PROPOSED WORKS
 EXISTING 3No. A0C4518R8x06 ANTENNAS TO BE RAISED ON NEW
 CRANKED ANTENNA SUPPORT POLES FOR ICNIRP COMPLIANCE

Site Name & Address:
**THE GALLERIA, COMET WAY
 HATFIELD, HERTFORDSHIRE
 AL10 0XR**

Title:
**TELECOMMUNICATIONS
 ROOFTOP UPGRADE
 SITE LOCATION**

Drawing No:
WEH010 - 01

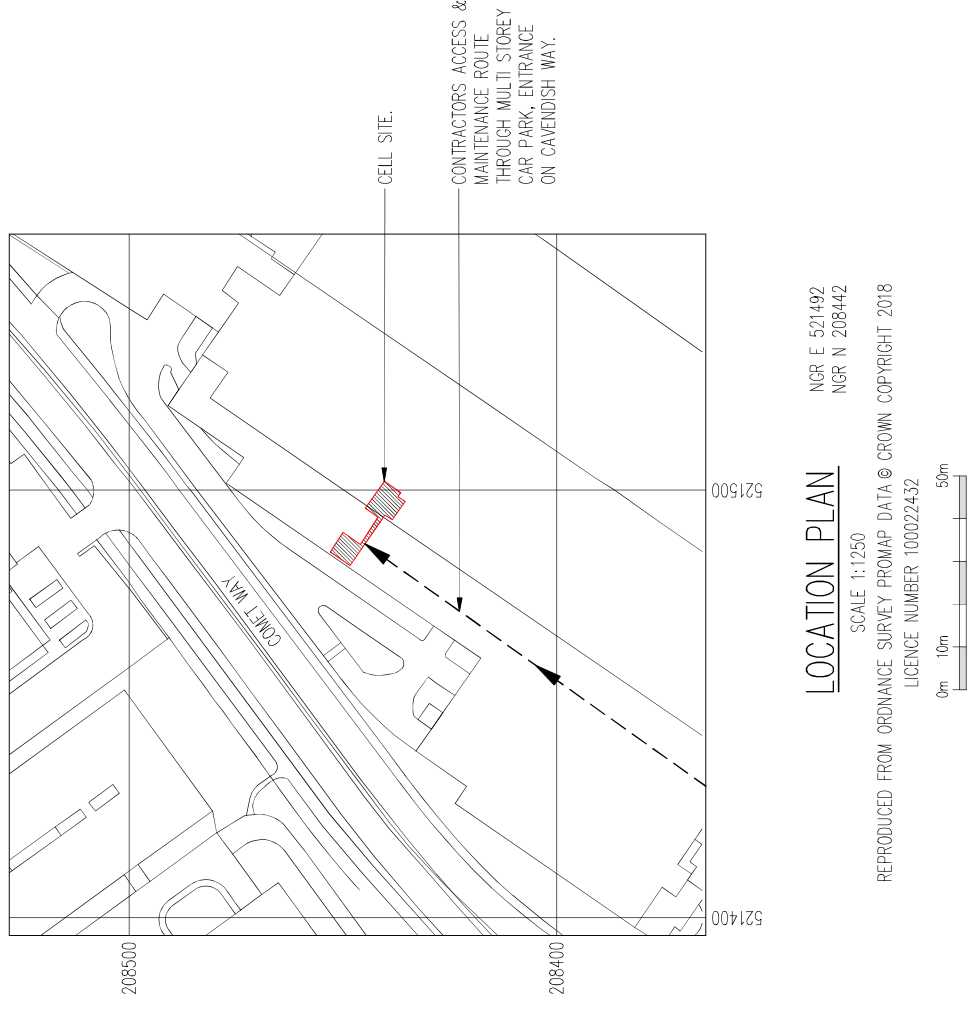
EE OPERATOR STATUS : **A**
 NOTE: A0C4518R8x06 ANTENNAS
 TO BE RAISED TO 27.6m FOR
 ICNIRP COMPLIANCE

Fixt No: 56249
 Approved By: **Turner Townsend**
 Status Date: **14/04/2021**
 Comments: **PROX-5 RF Compliance Report 61149- THE GALLERIA Date of Assessment: 14/02/21 Assessor: Anthony Eye**
Fixt ID: 56249 Drawing Rev: Drawing Date: 08/03/2021 Project Strategy Lite Subject to Concrete >100mm: N/A Site has
been modelled in ProX5 using drawings provided by WHP: 08/03/2021 WEH010 THE GALLERIA_61149_EE Strategy
Lite-interim_01-24_A5_PA Previous Fixt 23150 was assessed previously, assuming that the upper level was occupiable. A
only, due to the presence of comms room, AC units etc. However, it has now been identified as public accessible. A
ProX-5 assessment is required to identify the design changes required before going in to build. Operators on Site EE,
H3C, Sector A - T&A Step 4.0 - is Not Compliant, Sector B - T&A Step 4.0 - is Not Compliant, Sector C - T&A Step 4.0

- is Not Compliant It has been identified to achieve ICNIRP compliance, the proposed AOC antennas require raising by 1m
from 26.6m to 27.6m C/A, CONTRACTOR DUE DILIGENCE: The provision of suitable access controls / signage / awareness
is required to restrict access. Enquiries - MBULRFCompliance@turntown.co.uk
